Dear Reviewer #2,

This paper deals with rainfall-runoff modelling and proposes a new routing scheme adapted from the principle of geomorphological and distributed unit hydrographs (Rodriguez-Iturbe and Valdès, 1979; Maidment et al., 1996). The new proposed scheme is called Dynamic Time Varying Unit Hydrographs, since it combines i) a variation of flow velocities depending on the rainfall intensities and the saturation level of the basin, and ii) a variation of the flow contributing areas considered to generate the unit hydrograph, which are assumed to correspond to the saturated areas. This basic assumption of runoff dominated by saturated areas of course limits the potential of application of the method (contributions from saturated areas should dominate the other flow generation processes), but this limitation is clearly stated in the conclusions of the manuscript, and this assumption seems to be valid in the presented case studies (humid basins).

**Figure 1.** (a) Tension water storage capacity curve, and (b) Free water storage capacity curve

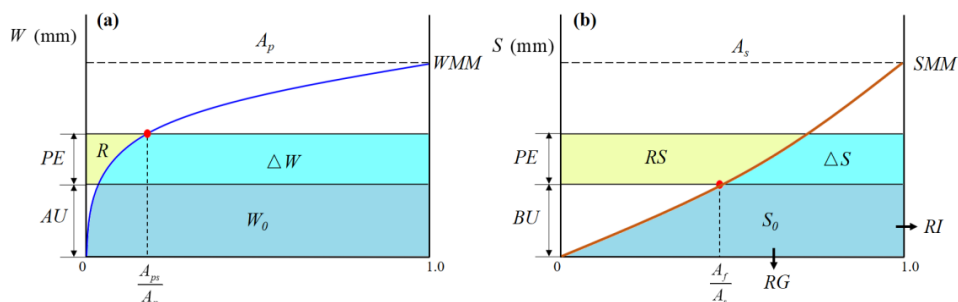
**Comment 1:** The description of the hydrological model is not sufficiently clear (consistency and links between equations, variables and parameters, description of parameters to be calibrated). See my detailed remarks below

We are sorry for the unclear description of the methodology. We will rewrite this part, and two pictures of the tension water storage capacity and free water storage capacity curves will be added to clarify the modelling process of the XAJ model. The revised version is as follows:

In the XAJ model, two parabolic curves are adopted to represent the spatially non-uniform distribution of the tension water storage and free water storage. The difference between field capacity and total soil water content is defined as tension water storage capacity, the maximum amount of water available in unsaturated zone. In the XAJ model, a tension water capacity curve is introduced (Fig. 1(a)) to describe the non-uniform distribution of tension water capacity throughout basin or sub-basin. In Fig. 1(a),  $A_{ps}$  is the partial pervious area where the tension water storage capacity is less than or equal to the value  $W$ , which is the tension water capacity at a point, varying from 0 to a maximum  $WMM$ ;  $A_p$  is the pervious area;  $W_0$  is the initial areal mean tension water storage (mm); and  $AU$  is the vertical coordinate corresponding to  $W_0$ . The functional relationship of the tension water storage capacity curve is expressed as:

**Figure 4.** Line chart of the  $NSE$ ,  $RMSE$ ,  $Q_p$  and  $T_p$  for the Longhu River basin.

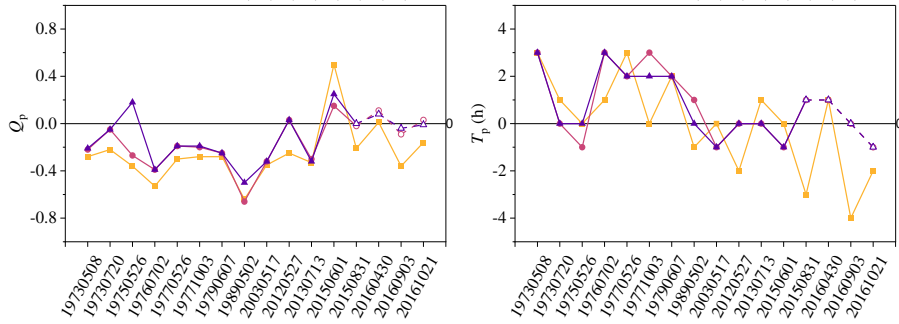
**Comment 3:** The methodological choice to use only the XAJ+LR calibration for the evaluation of the XAJ+TDUH and XAJ+DTDUH models does not appear relevant to me. This leads logically to better performances of the XAJ+LR models, and may also advantage one of the two other XAJ+TDUH and XAJ+DTDUH models. The calibration results of the XAJ+TDUH and XAJ+DTDUH models (appendix) suggest that DTDUH does not perform as well as expected. I think that to achieve robust conclusions all the models should be calibrated and evaluated in validation (with a comparison of calibrated parameters).

Thank you for your comments. We will calibrate the three models (XAJ+LR, XAJ+TDUH and XAJ+DTDUH), respectively, and these results will be added in the revised manuscript.

Table 3 lists the  $NSE$ ,  $RMSE$ , error of flood peak ( $Q_p$ ) and error of time to peak ( $T_p$ ) values for all the models of the Longhu River basin, among which No. 20150831, 20160430, 20160903 and 201651021 are validation dataset. To demonstrate the model performances of different strategies more visually, Fig. 4 shows line charts of the three runoff routing methods for the four indexes in both calibration and validation periods. Results shows that TDUH and

**Figure 1.** (a) Tension water storage capacity curve, and (b) Free water storage capacity curve

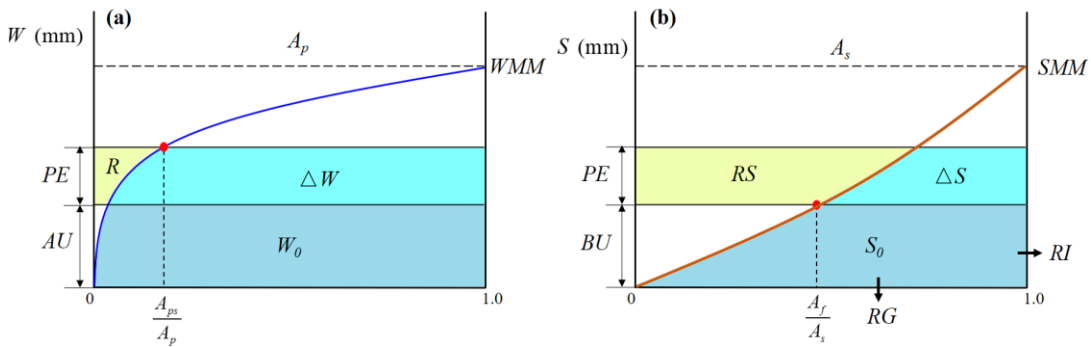
**Comment 14:-** 1.128 – 153 This description of the production part of the hydrological model is not clear. Please define more clearly each notion and variable ( $A_{ps}$ ,  $A_p$ ,  $A_f$  and  $A_s$ , free water storage and tension water storage,  $AU$ ,  $FR$ ,  $BU$ ,  $S$ ,  $SM$ , ..), and the way they are used and related, if necessary by including additional figures. Figure 2 could be placed here, but it does not provide a sufficient level of detail to understand how the model’s variables and parameters are related. Finally, I do not understand how the areas  $A_{ps}$ ,  $A_p$ ,  $A_f$ ,  $A_s$  are used in the computation, and how eq. 3 and equations 4, 5, 6 can be combined to ensure a conservation of volume (I guess  $R$  should be equal to  $RS+RI+RG$  but this does not seem consistent with the equations)

- ① We will add a diagram of the free water storage and tension water storage (Fig. 1).
- ② We will define each notion and variable more clearly.
- ③  $A_{ps}$ ,  $A_p$ ,  $A_f$ ,  $A_s$  are used in Eqs. (2) and (4), to calculate the total runoff and the surface runoff, interflow and groundwater.
- ④  $R$  is equal to  $RS+RI+RG$ , and it will be added in the revised manuscript.

The difference between field capacity and total soil water content is defined as tension water storage capacity, the maximum amount of water available in unsaturated zone. In the XAJ model, a tension water capacity curve is introduced (Fig. 1(a)) to describe the non-uniform distribution of tension water capacity throughout basin or sub-basin. In Fig. 1(a),  $A_{ps}$  is the partial pervious area where the tension water storage capacity is less than or equal to the value  $W$ , which is the tension water capacity at a point, varying from 0 to a maximum  $WMM$ ;  $A_p$  is the pervious area;  $W_0$  is the initial areal mean tension water storage (mm); and  $AU$  is the vertical coordinate corresponding to  $W_0$ . The functional relationship of the tension water storage capacity curve is expressed as:

**Figure 2.** Schematic diagram of the XAJ model

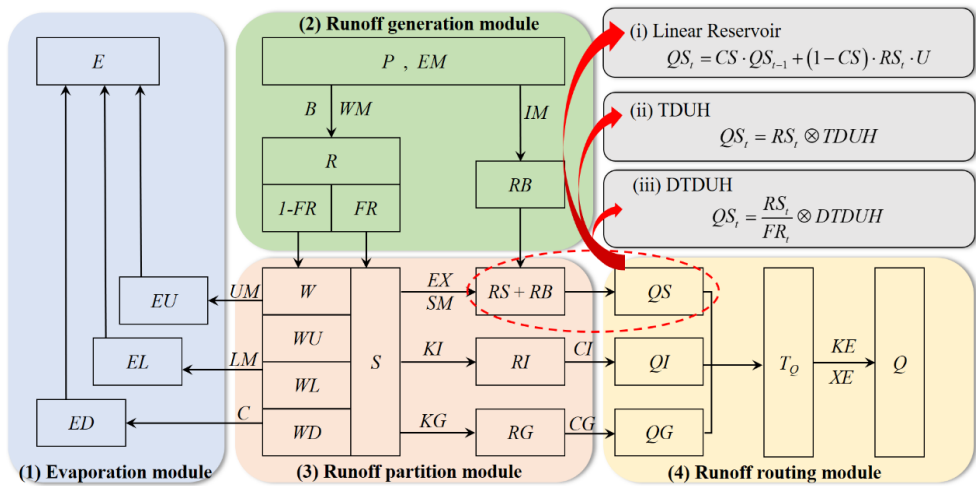
**Comment 20:**Figure 2. According to this figure and the text, it seems that the routing schemes are applied only on RS (surface runoff). Could you explain what happens with subsurface and groundwater components (RI and RG): are they also routed and how?

Thank you for your comments. Fig. 2 presented the schematic diagram of the XAJ model. For the runoff routing module in the XAJ model, the subsurface stormflow (RI) and subsurface runoff (RG) were considered using a free reservoir, but the proposed routing schemes are applied only on RS. Their expressions are given by

**Figure 3.** Details of the runoff components of the 16 flood events for the (a) Longhu River basin. (b) Dongshi River basin.

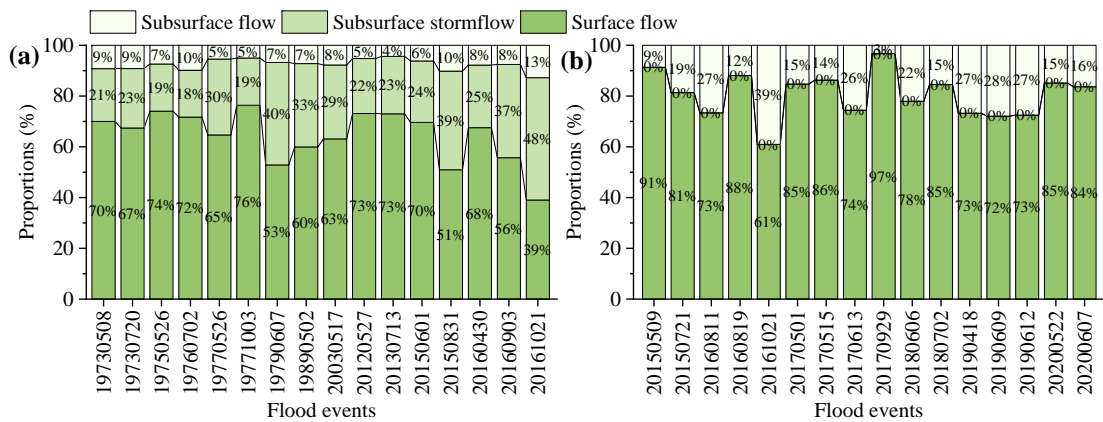
**Comment 21:-** 1.224 – 230 Again here, it is suggested that the discharge at the basin outlet is computed by routing only the surface runoff and is resumed to QS. Can you at least explain if Qi and QG are neglected and if the validity of this assumption has been verified for the presented case studies?

First, the discharge at the basin outlet is computed by routing all the three runoff components, including RS, RI and RG. The surface runoff (RS) was routed using the unit hydrograph, and the subsurface stormflow (RI) and subsurface runoff (RG) were considered using a free reservoir.

The performances of the model were evaluated based on the flow hydrograph at the outlet of the watershed, and the flow hydrograph was composed by three components including the

**Figure 4.** Line chart of the  $NSE$ ,  $RMSE$ ,  $Q_p$  and  $T_p$  for the Longhu River basin.

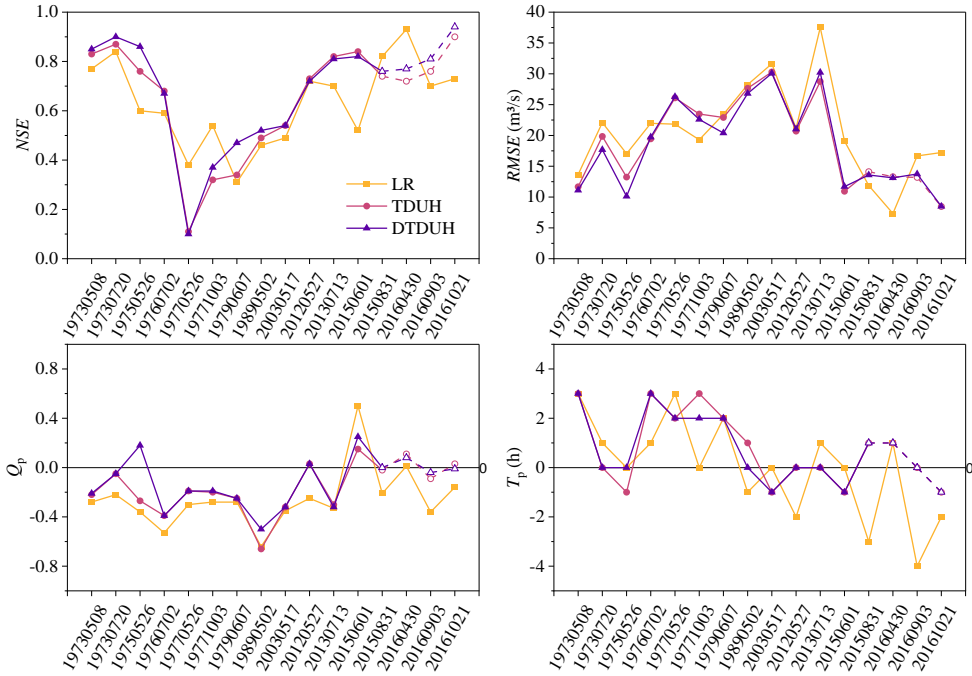
**Comment 31:-** 1. 306-324 The methodological choice to keep only the XAJ+LR calibration results, for the evaluation of the two other models (XAJ+TDUH and XAJ+DTDUH) seems very surprising to me, since the calibration results resented in appendix suggest that these two model may perform similarly to the XAJ+LR model, when appropriately calibrated. Moreover, the choice to calibrate the models on the whole dataset (without preserving validation data) is also curious. I think it would have been more relevant to calibrate the three models, and to preserve a validation dataset and/or to provide cross validation results.

Thank you for your comments. We have calibrated the three models (XAJ+LR, XAJ+TDUH and XAJ+DTDUH), respectively, and these results will be added in the revised manuscript.

**Figure 6.** Tension water storage capacity curve

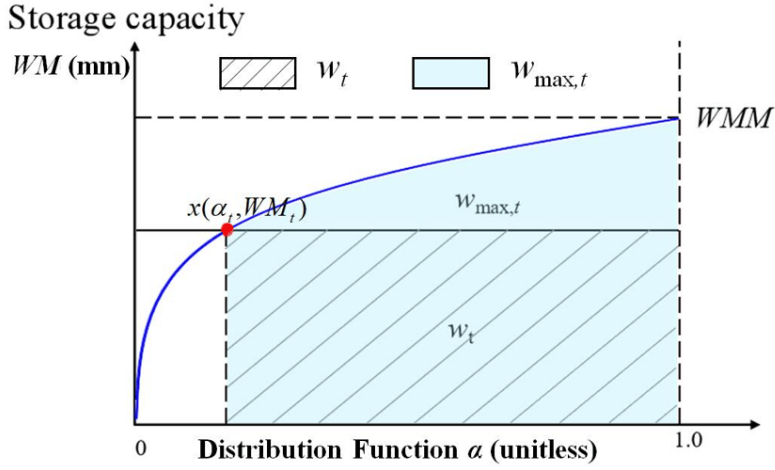
**Comment 32:-** 1.337-347 Could you explain here how do you retrieve the value of  $\alpha_t$  based on the structure of the model presented in figure 2? Could you also mention how the value of  $\alpha_t$  is converted to a saturated surface: assumption that  $\alpha_t=x$  corresponds to a x% of saturated cells in the watershed (corresponding to the x% cells having the largest TWI values)?

First, sorry for being unclear here. We will correct  $\alpha_t$  as  $\theta_t$  in the revised manuscript.

Fig. 6 shows the tension water storage capacity curve in the XAJ model, and the specific formula (Moore, 1985) is given by Eq. (10)
